From: [REDACTED]
To: [REDACTED]
CC: [REDACTED]
Sent: 2/24/2021 9:33:33 AM
Subject: RE: O8W-PM 35217268, 35224712, 35224713 - Bucks Creek 1101 Phase 1,2&3 - Pre-Engineering Meeting

Subject: O8W-PM 35217268, 35224712, 35224713 - Bucks Creek 1101 Phase 1,2&3 - Pre-Engineering Meeting

PM 35217268 (Phase 1)

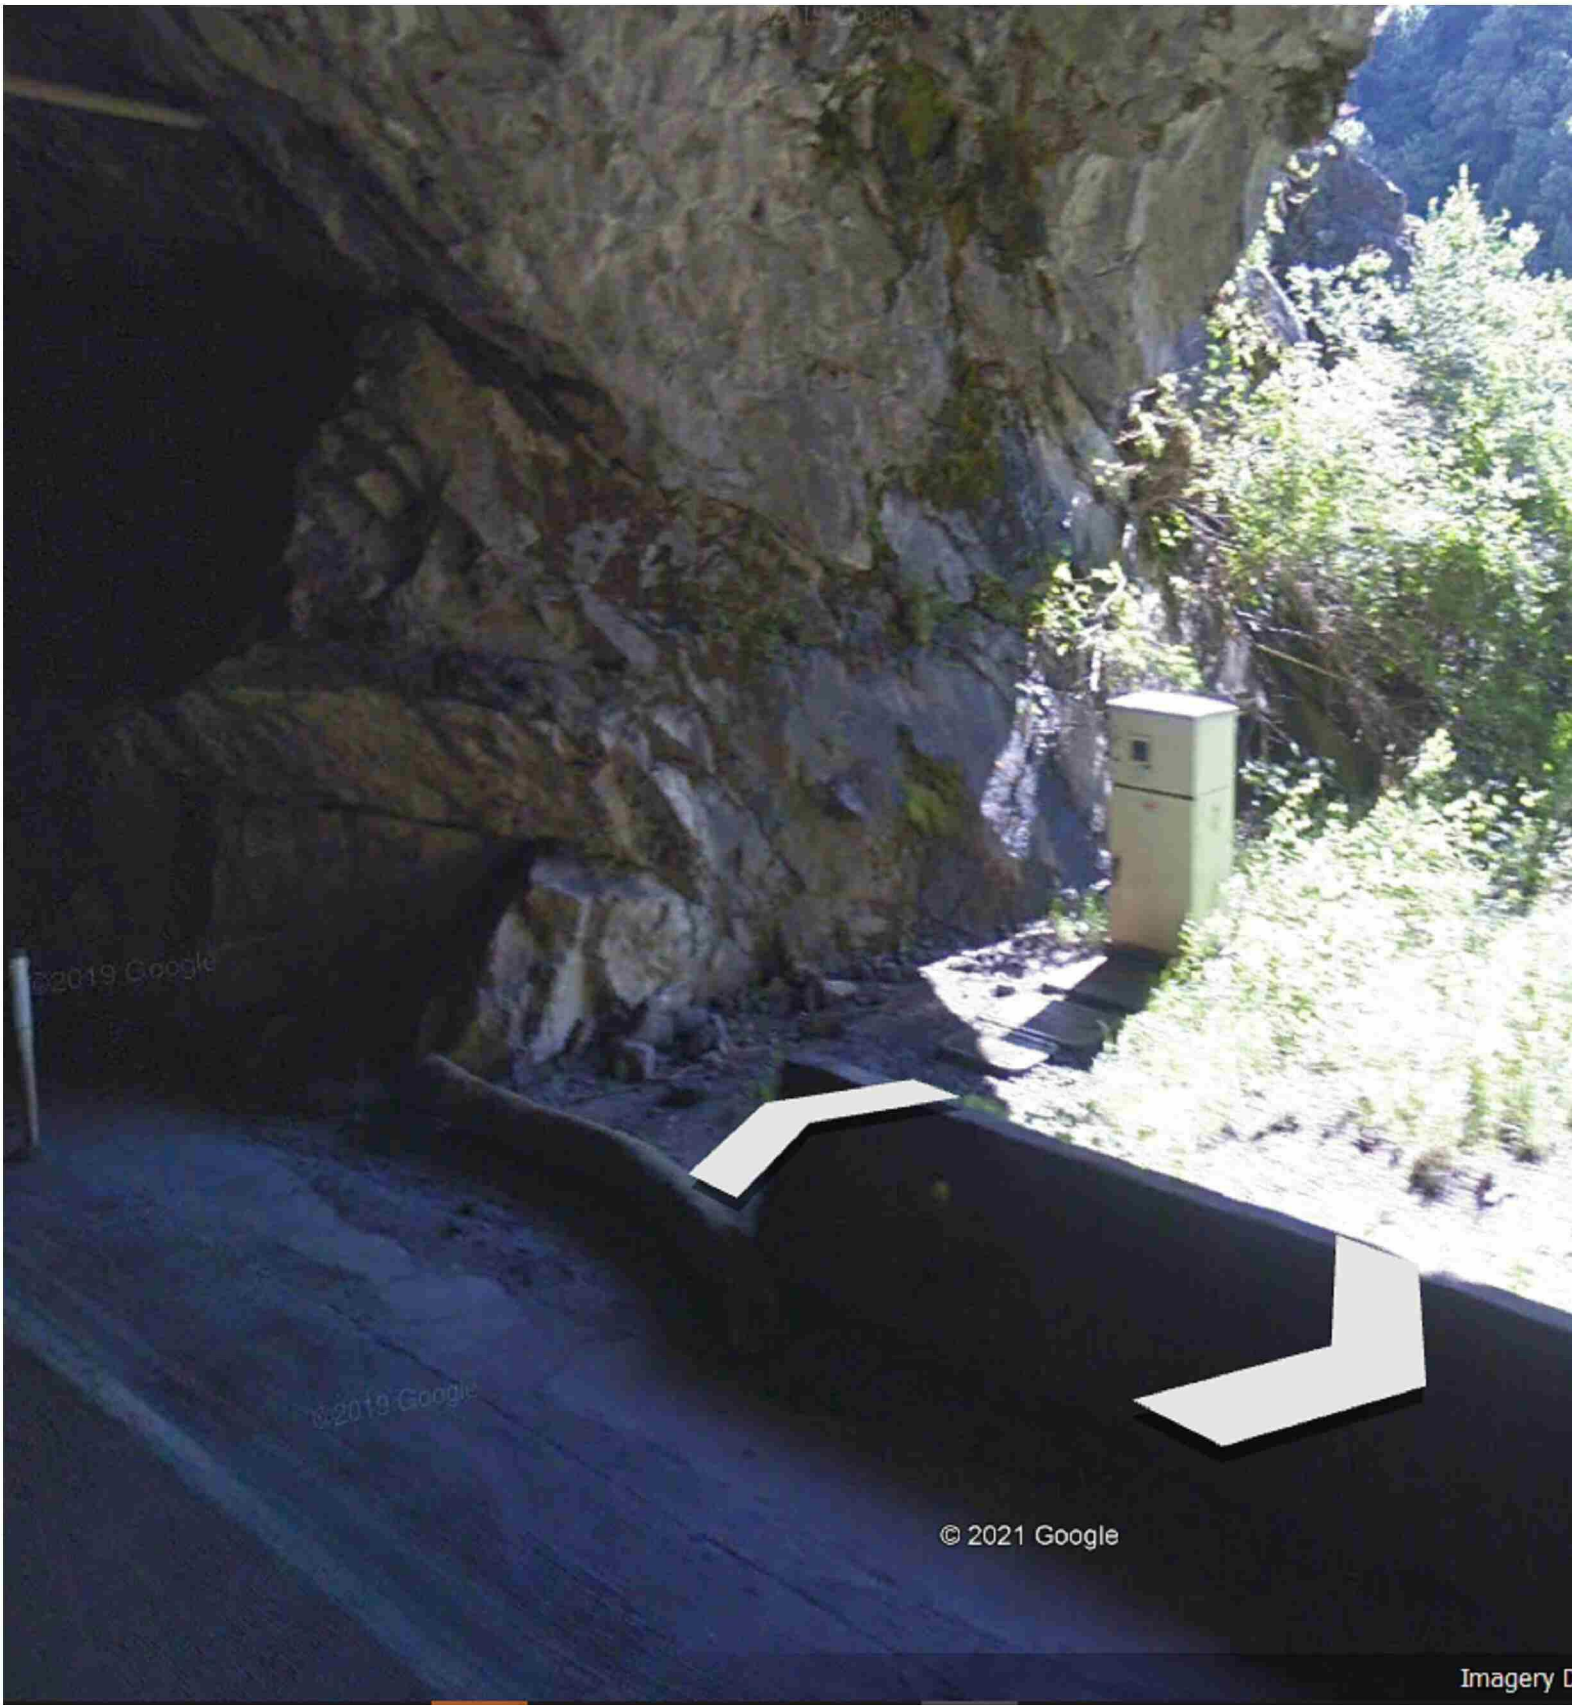
Attached are the 'base-map' limits in a kmz. file. As you will see, we need our base-map to go about ~100' into the tunnel at the south end (see pedestal in picture below....please begin about ~50 beyond this point which is about ~100' beyond the Cresta Dam).

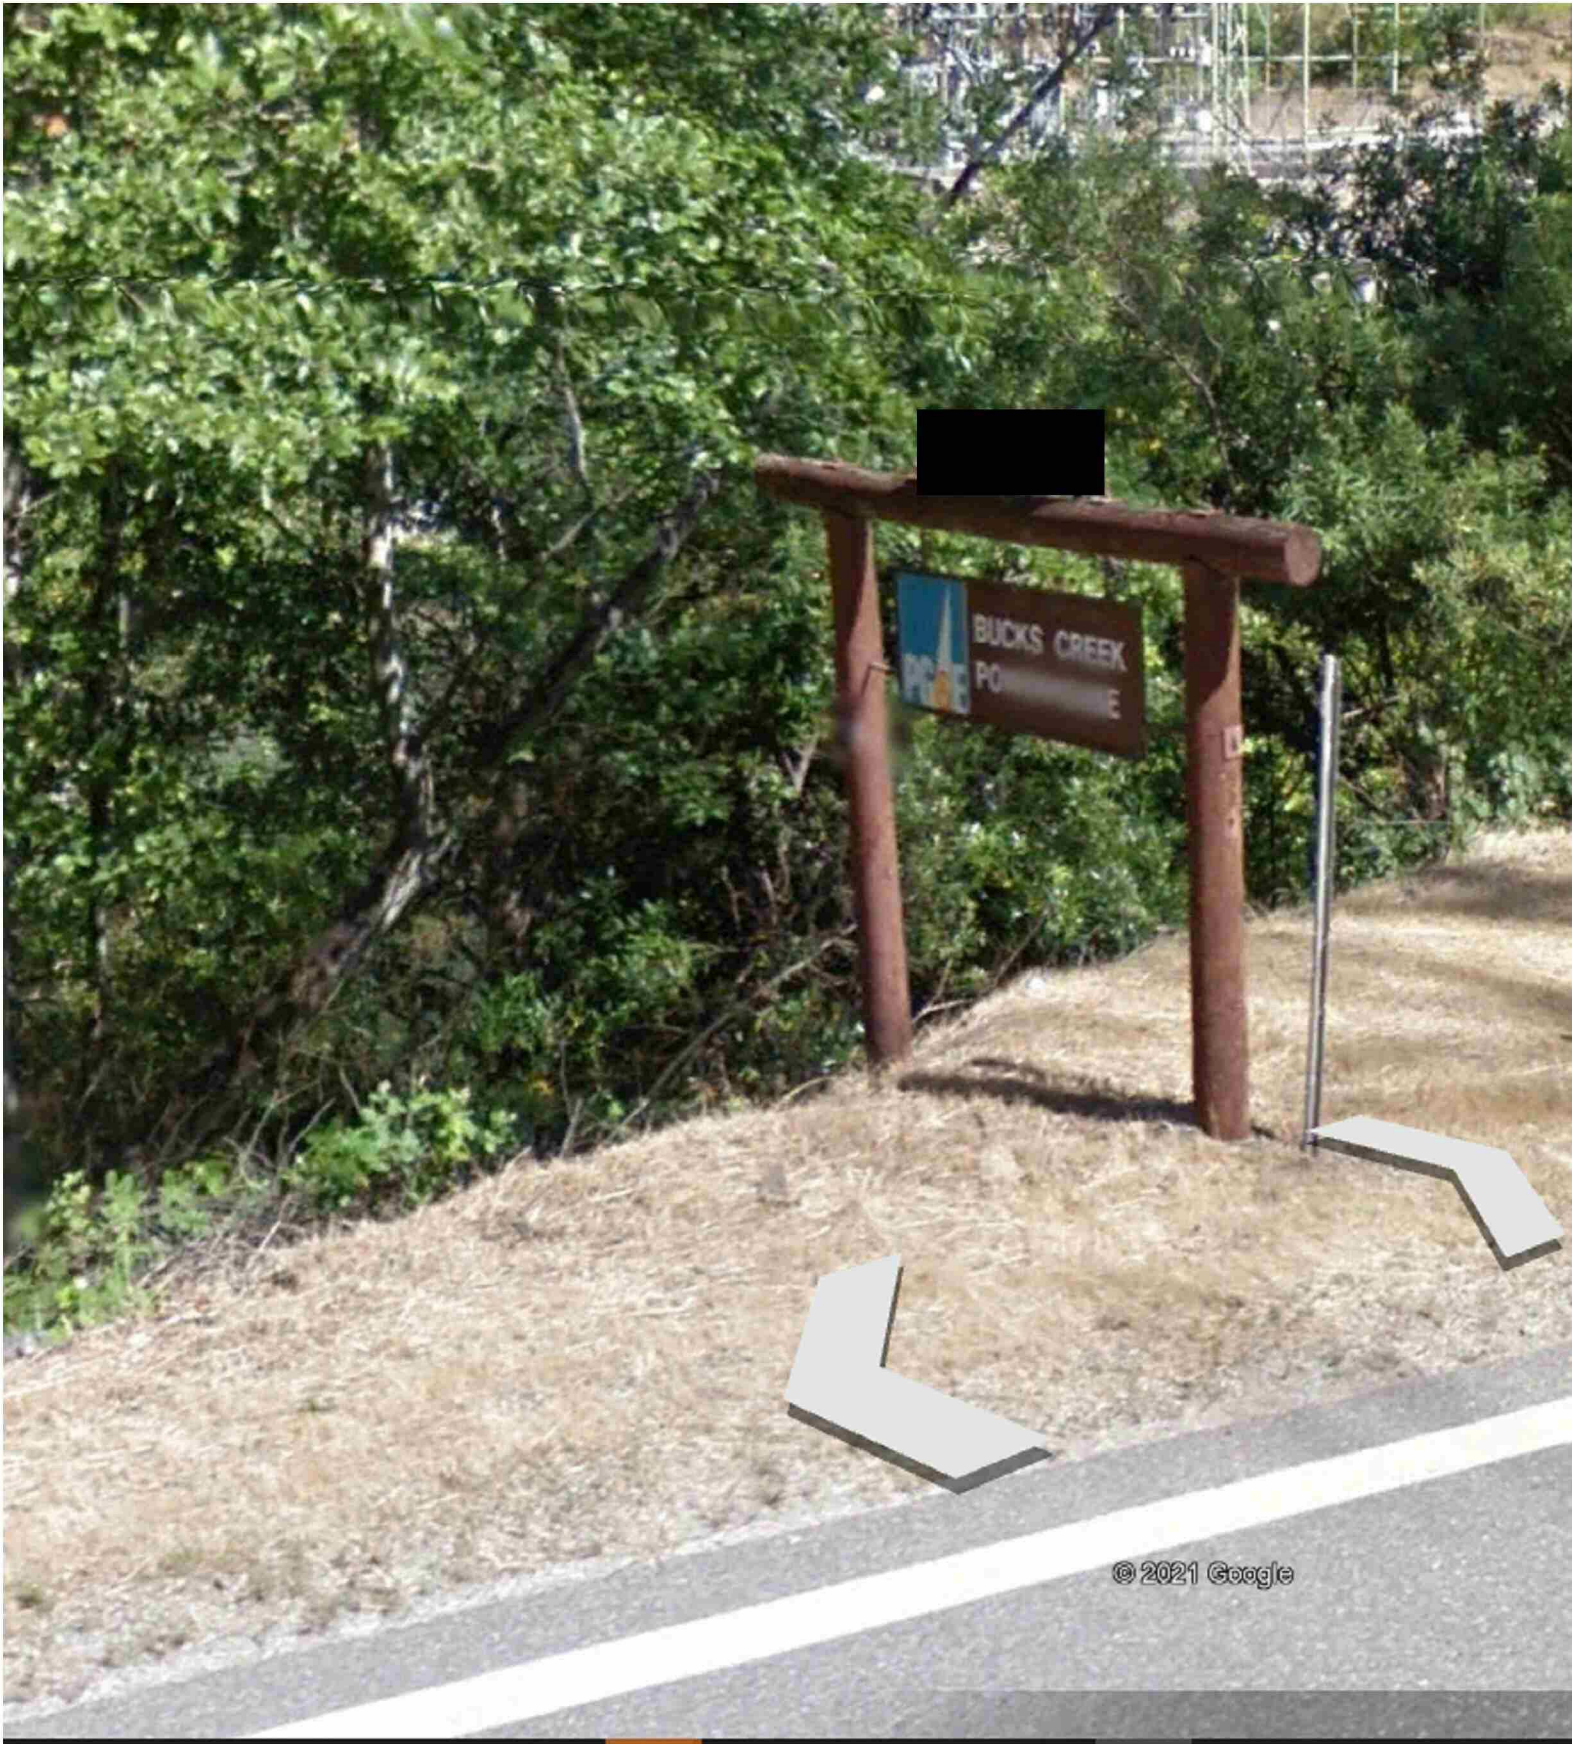
We want to end the base-map at the sign location below which is roughly at MM (Mile Marker) 5.10.

Overview Map

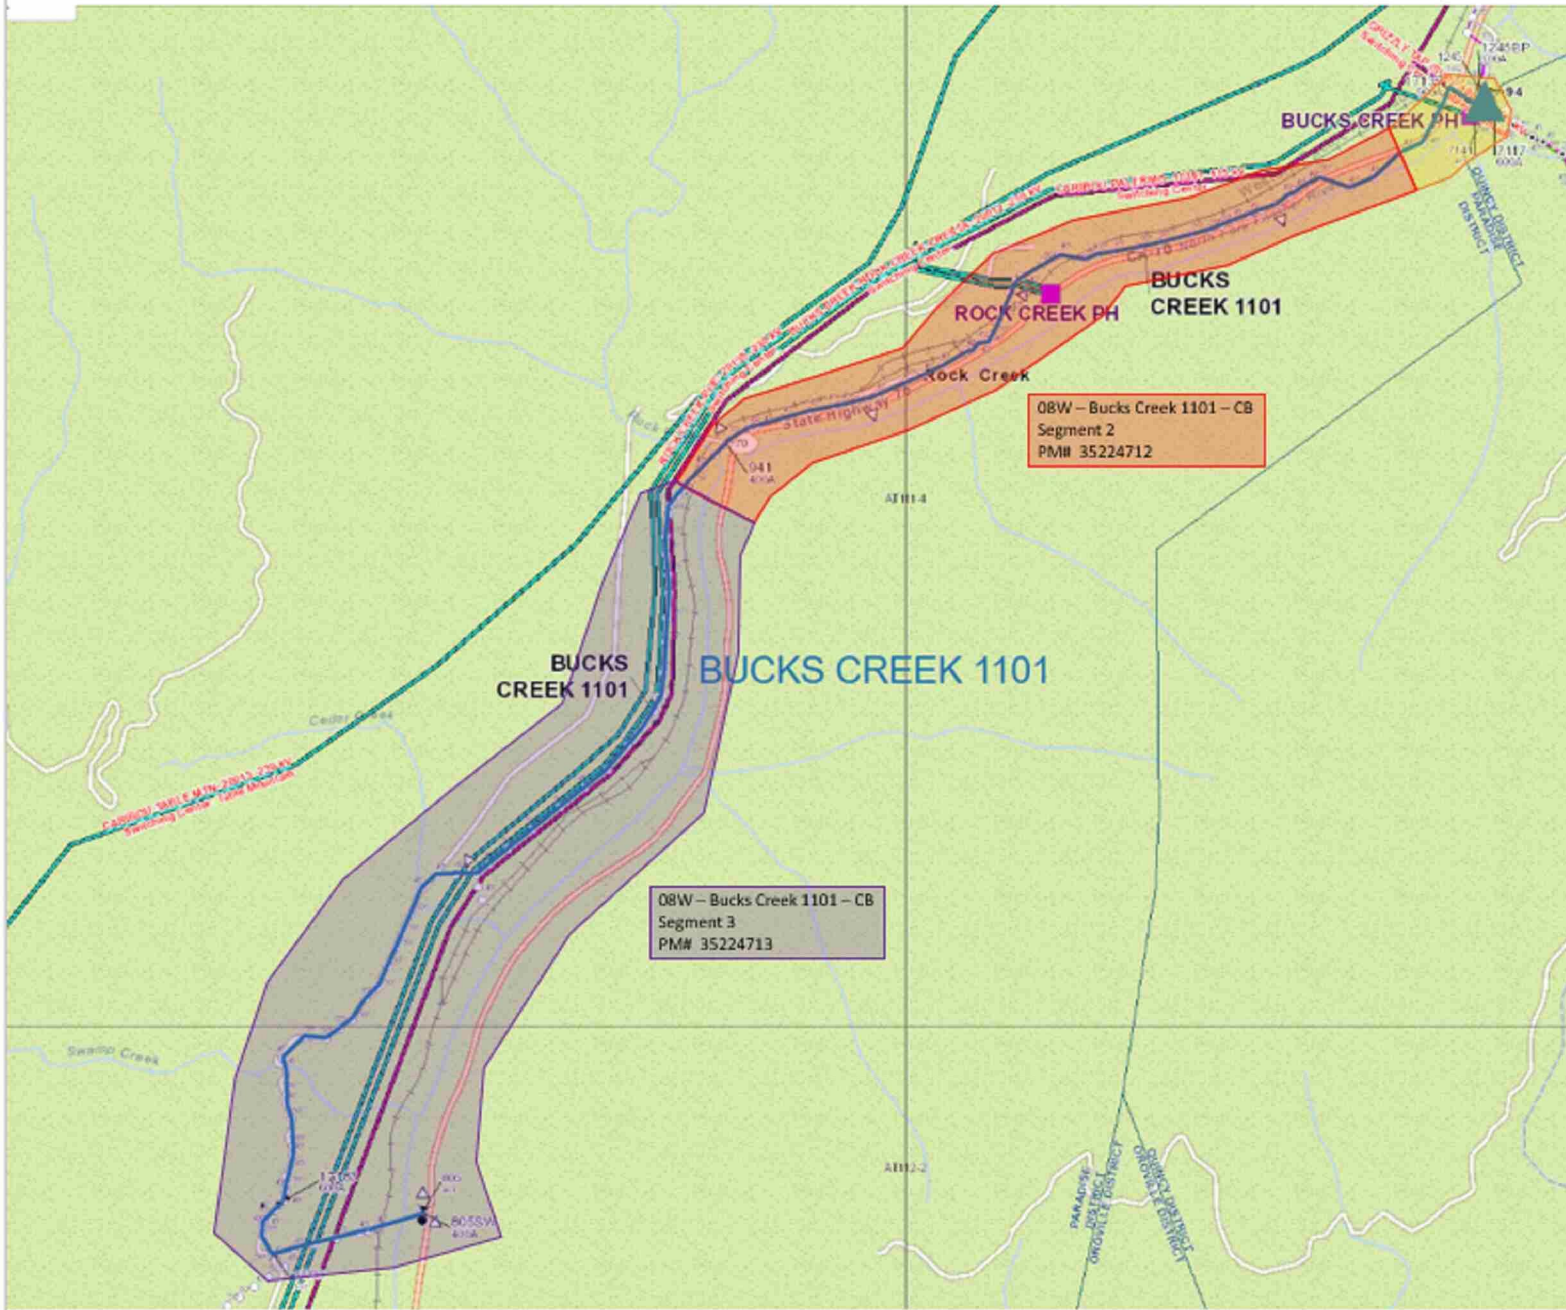
For Bucks Creek there is quite a bit of work surrounding Hwy 70 and we will need a Land Department Base Maps prepared for all 3 Orders. This will delay the EOD dates until these can be developed and provided to the Vendor... We will also need answers to the questions outlined by [REDACTED] below...
